Type <b>Coffee Vending Machine</b>	Model <b>9100</b>	N° T.I. <b>04 - 2018</b>
Serial Number <b>81212224</b>	Subject <b>NEW NOZZLE SUPPORT</b>	ISSUED FOR (X) Action Information <b>X</b>

To make it easier to remove and clean the **nozzle support**

**Pre-modification nozzle support assembly**

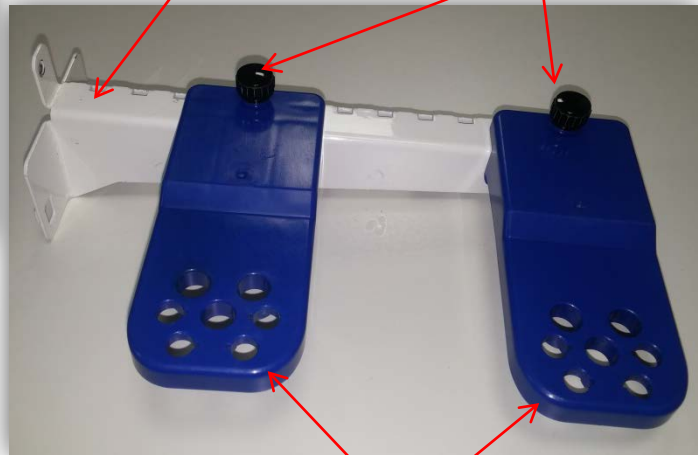
The *pre - modification* nozzle support assembly has been replaced by the **new** nozzle support.

The *pre - modification* solution is composed of the nozzle arm support, two plastic supports and two knobs.

The **new** nozzle support cleaning is faster compared with the *pre - modification* solution.

**New nozzle support**

Spare code: **261241**

The **new nozzle support** and the **pre-modification** solution are interchangeable.

✓ The **new nozzle support** spare code is: **261241 SAP 55119230**
